Response to U.S. EPR Design Certification Application RAI No. 265, Supplement 2

Response to

Request for Additional Information No. 265, Supplement 2

SRP Section: 03.06.03 - Leak-Before-Break Evaluation Procedures

Figure 03.06.03-21-1—Comparison between Aged and Unaged Data

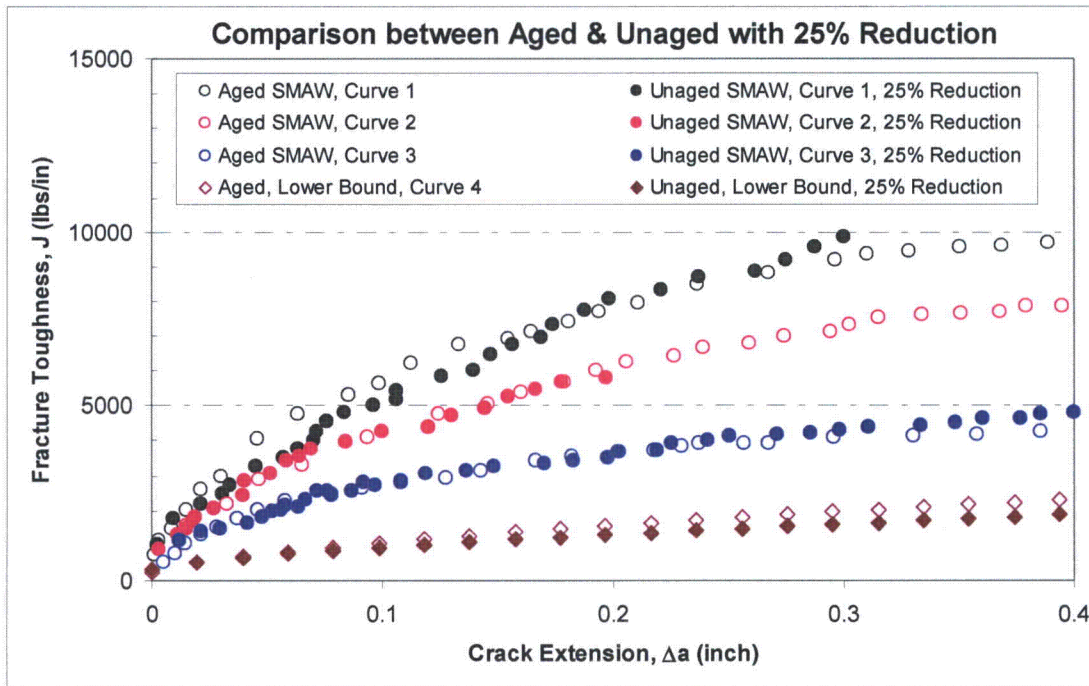
RAI Question 03.06.03-6 requested AREVA to provide details for the J-R curves used for ALL the calculations as none were provided in the original FSAR. AREVA provided the requested information during an audit conducted on June 26, 2008. The information presented to the staff during the audit indicated that for SST pipe and welds the toughness was reduced by 30% to account for thermal aging. In the formal response to RAI Question 03.06.03-6, dated 9/18/2008, AREVA indicated that the reduction in toughness was to account for heat to heat variations. The staff requests AREVA to provide the justification and the basis for the 30% reduction.

The 30-percent reduction seems to be in reasonable agreement with NUREG/CR-6428 ("Effects of Thermal Aging on Fracture Toughness and Charpy-Impact Strength of Stainless Steel Pipe Welds" by Argonne.) However, AREVA needs to review NUREG/CR-6428 and include their assessment of the NUREG and the level of support that the NUREG provides to their response.

[] . Because of its greater aging time and temperature, the data set from Reference 1 is a lower bound toughness data set for 316 GTAW/TIG welds. Four sets of public data (Reference 1 through Reference 4) fall below the data in Reference 1 (16-8-2 material aged for 100,000 hours at 900°F) as shown in Figure 03.06.03-21-1.

Reference 1 through Reference 4, shown in Table 03.06.03-21-1, are bounded by Huang's 16-8-2 data set, as shown in Figure 03.06.03-21-1.
